CONSOLIDATED RESPONSE TO AGENCY AND PUBLIC SUBMISSIONS (PARTS A, B and C)

PROJECT APPLICATION SANDON POINT

Don Fox Planning Pty Ltd

NOVEMBER 2008

Figure 6.1A – Schematic Locations of HECRAS Cross-Section for Hewitts Ck

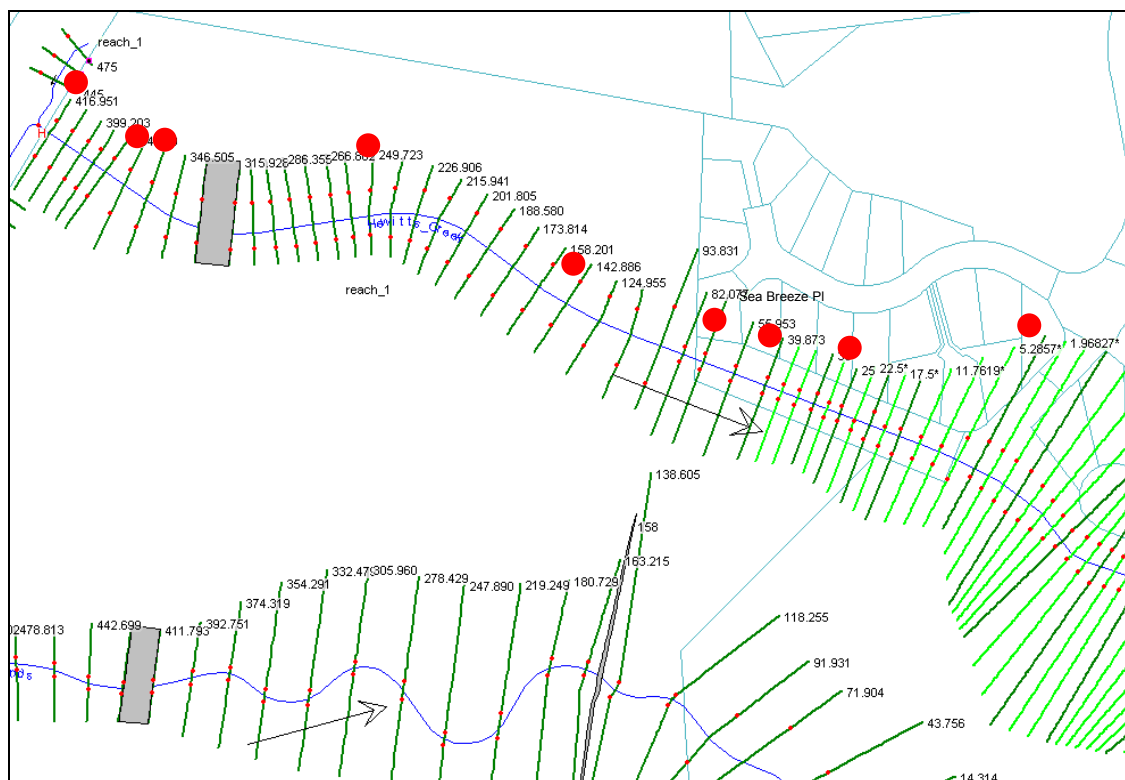
ISSUE 43 *CFR have neglected to use the flood levels based on the extreme upper bound of roughness coefficient $n=0.2$ for the riparian corridors to determine flood planning levels for the proposed Sandon Point development. This may result in building platforms becoming inundated in the future due to the significant establishment and lack of maintenance of these riparian corridors.*

Note: The 'red dots' (and chainages) correspond to the cross-section locations presented in Table 6.2A

ATTACHMENT A

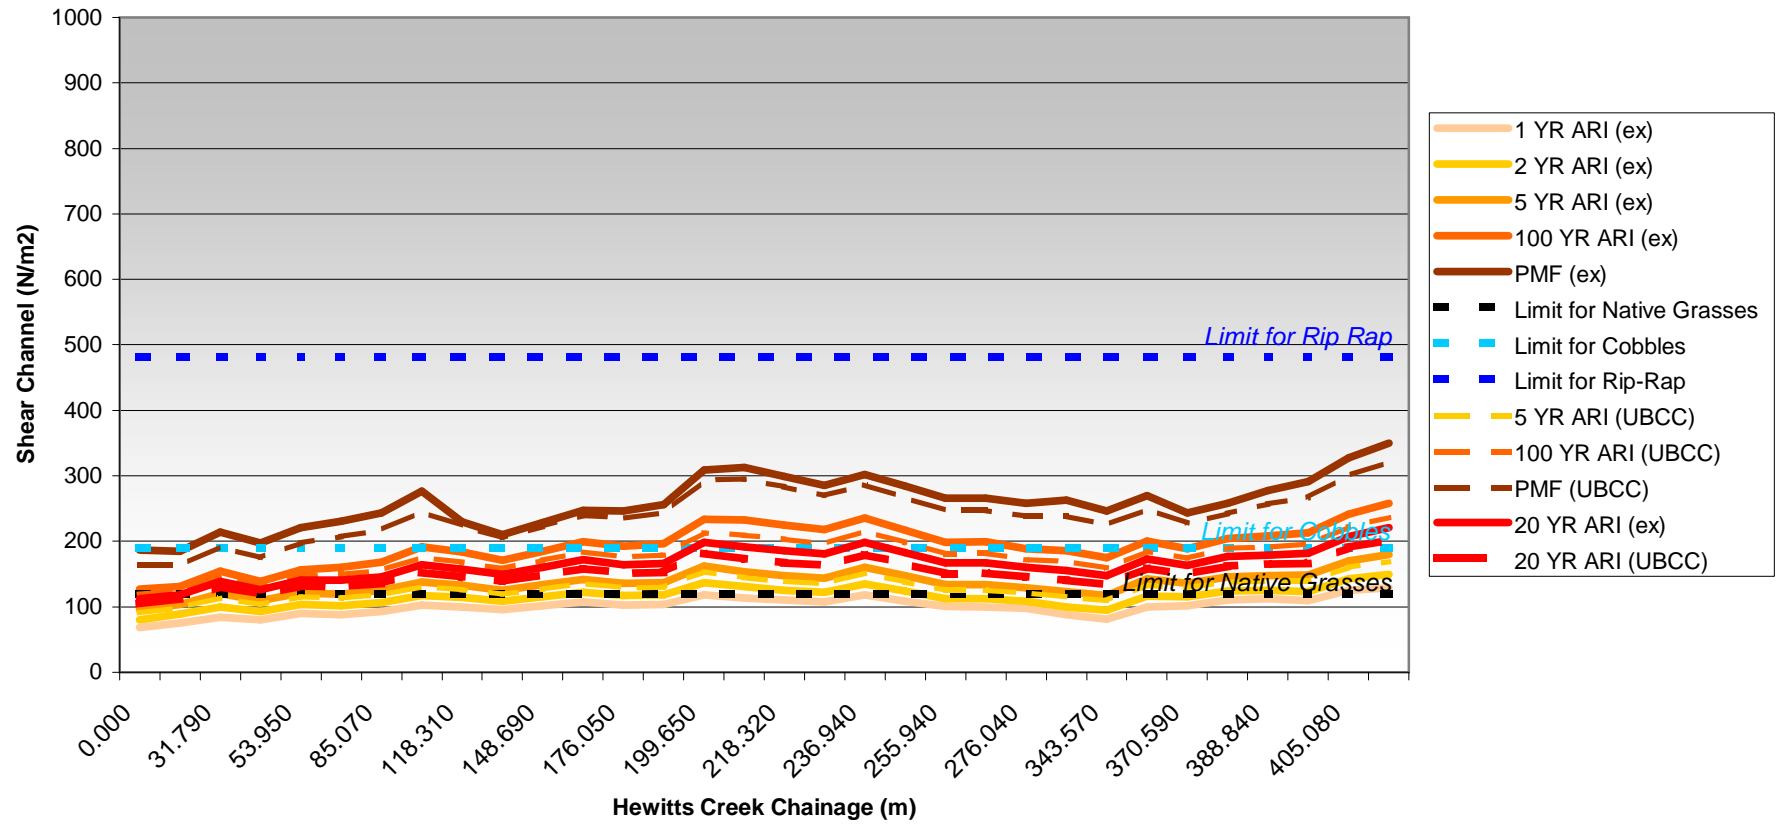
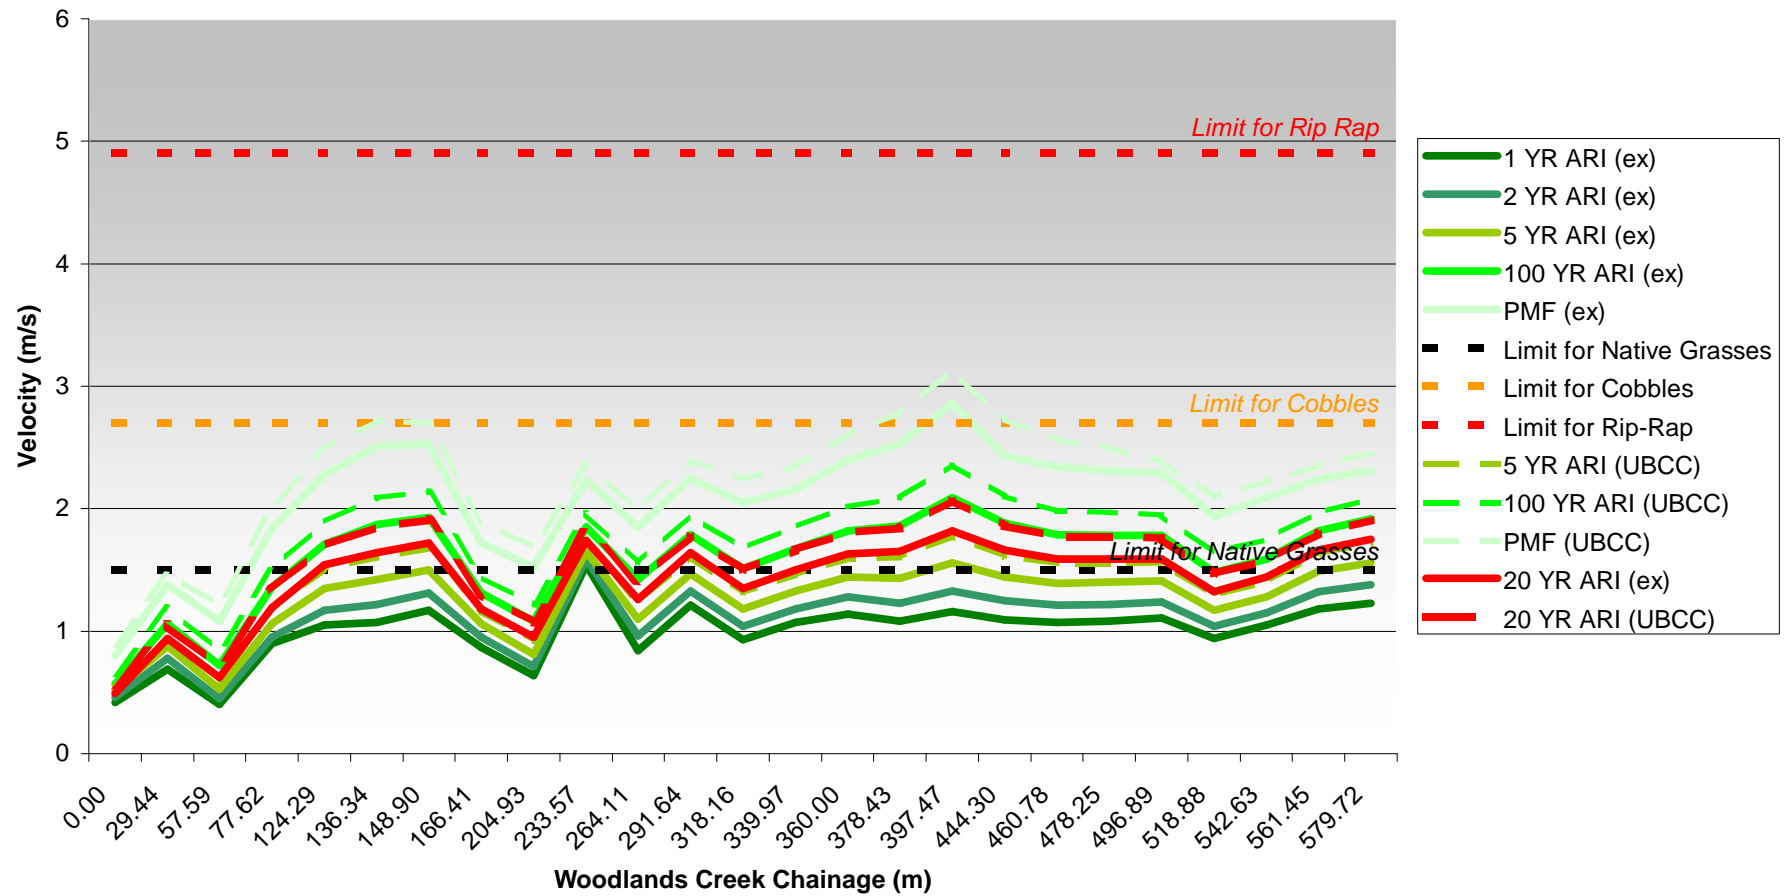
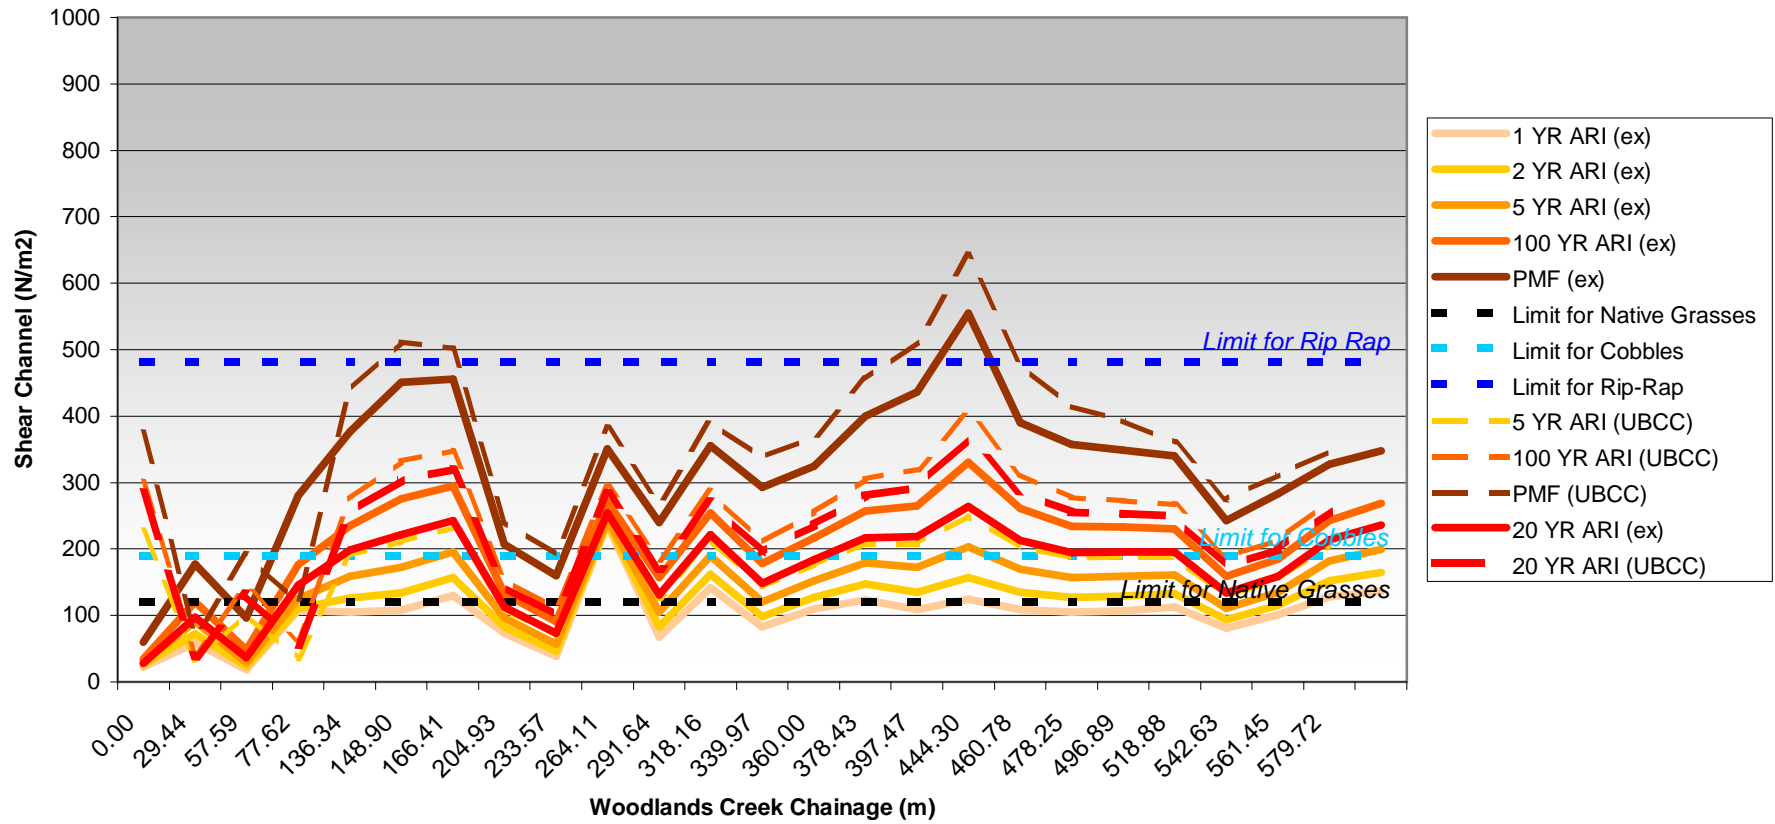
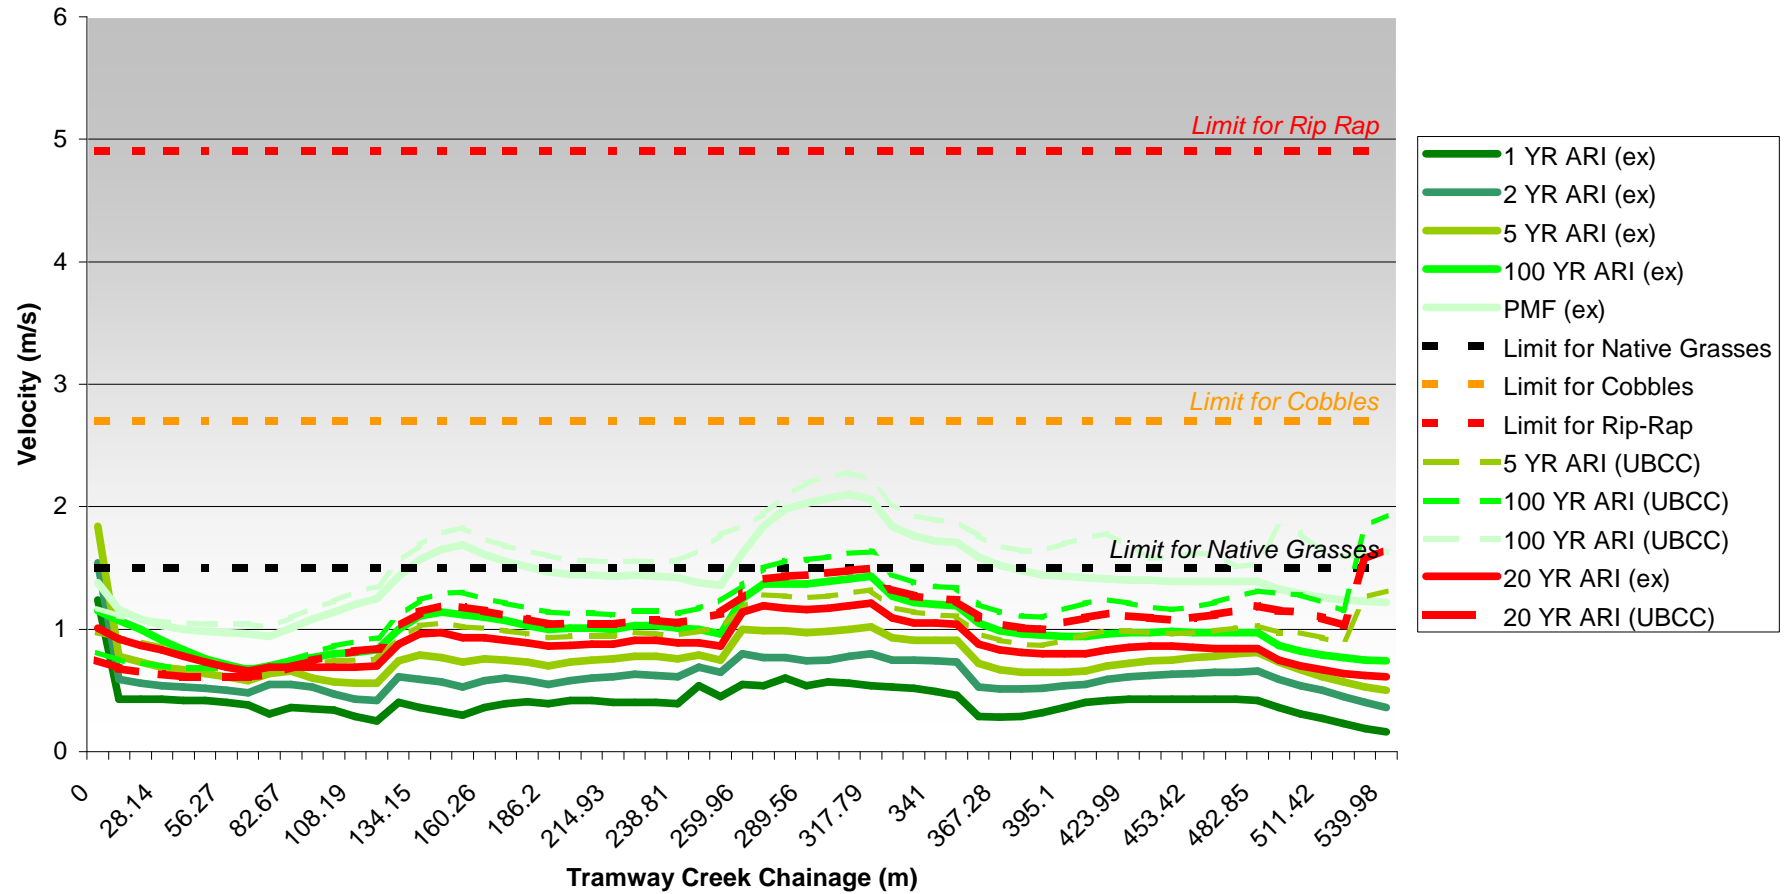
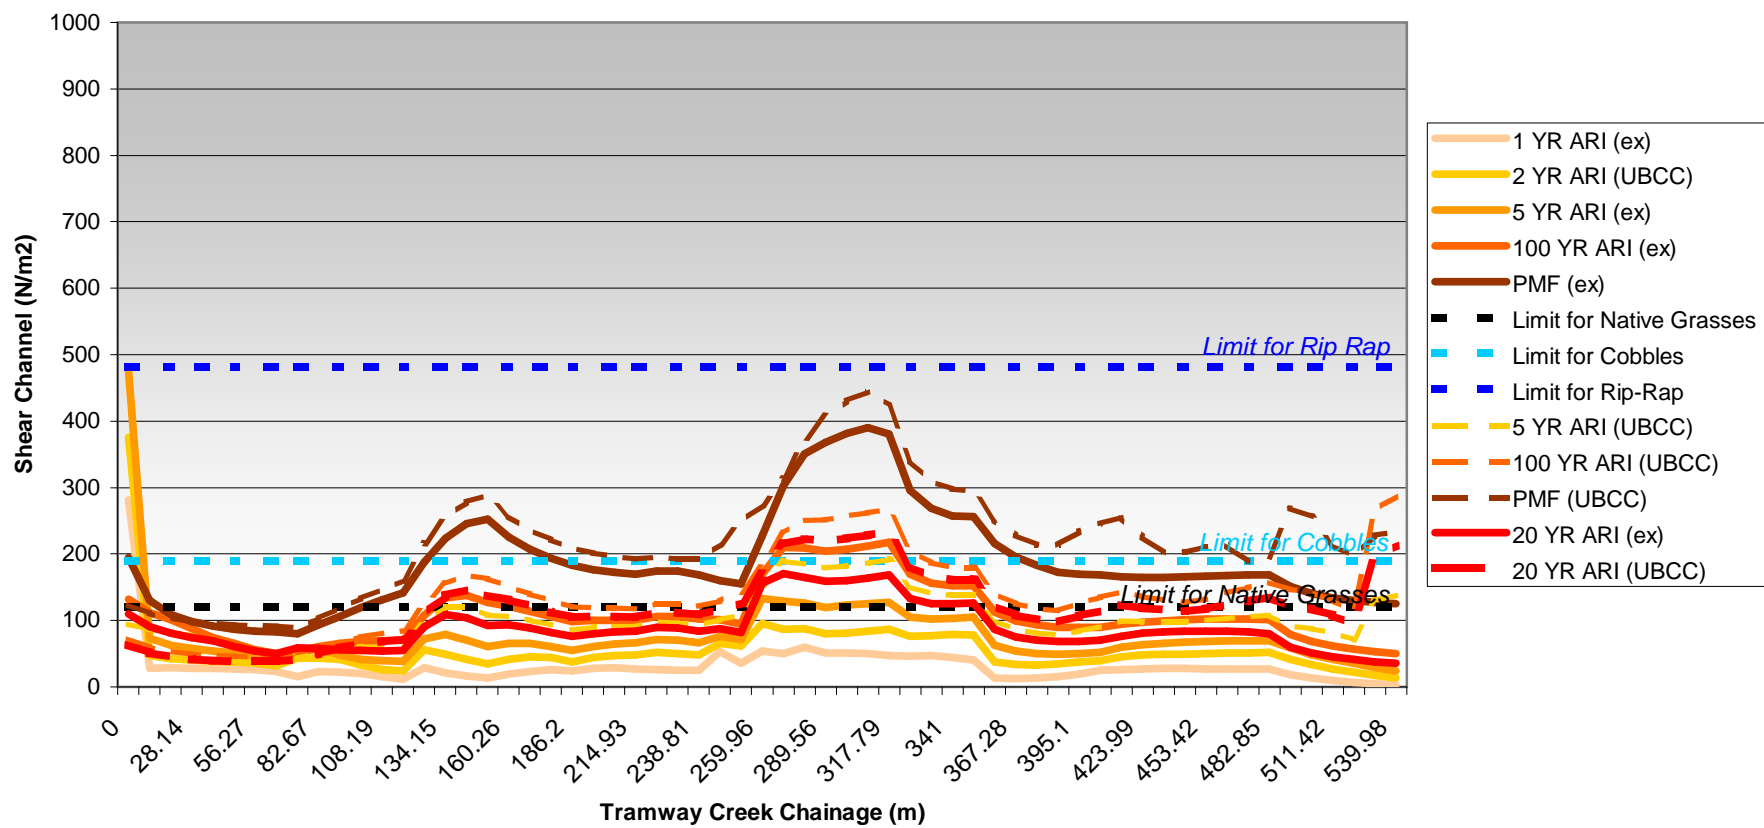
ISSUE 41 *The channel designs are inadequate to maintain channel stability up to the 20-year ARI as per the Director General's requirements for the climate change scenario. The scour protection proposed within the channels is only capable of protecting the channels up to a 5-year ARI based on the flow velocities and shear stress results found within the flood study.*

Flows for the 20 year ARI event were not included in the main body of text, but are fully detailed in Appendix F. The 20-year line was not shown on Figures 6.4, 6.5 and 6.6 as it clearly lies between the lines for the 5 year and 100 year ARI events. Irrespective of wherever the 20-year line plots between these two limits, the conclusions of the report are unchanged. Please refer to **Attachment A** for a set of figures with the 20-year lines added.

Flows for the 20 year ARI event were not included in the main body of text, but are fully detailed in Appendix F. The 20 year line was not shown on Figures 6.4, 6.5 and 6.6 as it clearly lies between the lines for the 5 year and 100 year ARI events. Irrespective of wherever the 20 year line plots between these two limits, the conclusions of the report are unchanged. Attachment A to CFR's letter (**Appendix A** of this report) contains figures with the 20 year lines added.

It is agreed (as is stated in the CFR 2008 report) that native grass planting alone in the channel will ensure stability in events up to the 5 year ARI. For larger events, up to and including the climate change 'upper bound' 100-year event, the use of cobbles in localised areas, (and possibly boulders in some limited locations) will produce a stable channel design using natural materials.

Figure 2A Typical Sections Through Woodlands Creek Railway Diversion Channel for the Existing Climate PMF Event

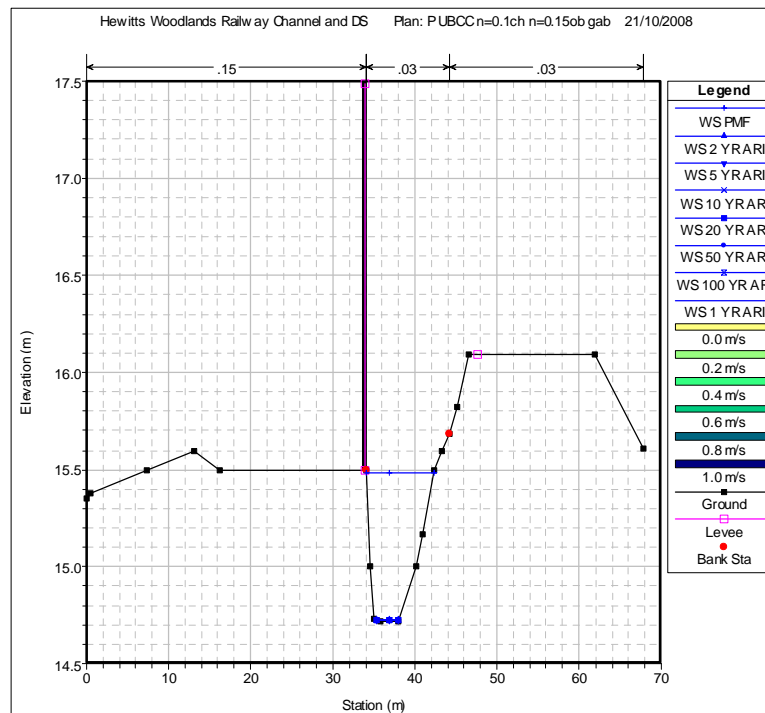
ISSUE 45 The flood study fails to clarify the impact of flooding on the development due to overtopping of the railway embankment in the PMF event. This was identified within the Hewitt's Creek Floodplain Risk Management Study and Plan (2002), but was not explored within the recent CFR Climate Change Study.

Flood waters in railway channels up to the PMF do not affect the proposed lots.

This figure demonstrates that the proposed channels designed to accept weir flows that overtop the railway embankment have the capacity to collect the full amount of flow and feed it back into Hewitts and Woodlands Creeks in all events up to the PMF. Flood waters DO NOT affect the proposed lots. It is noted that under future climate change conditions once Woodlands Creek culvert is upgraded (to be greater > 6 m dia), a reduced amount of flow will enter the channels.
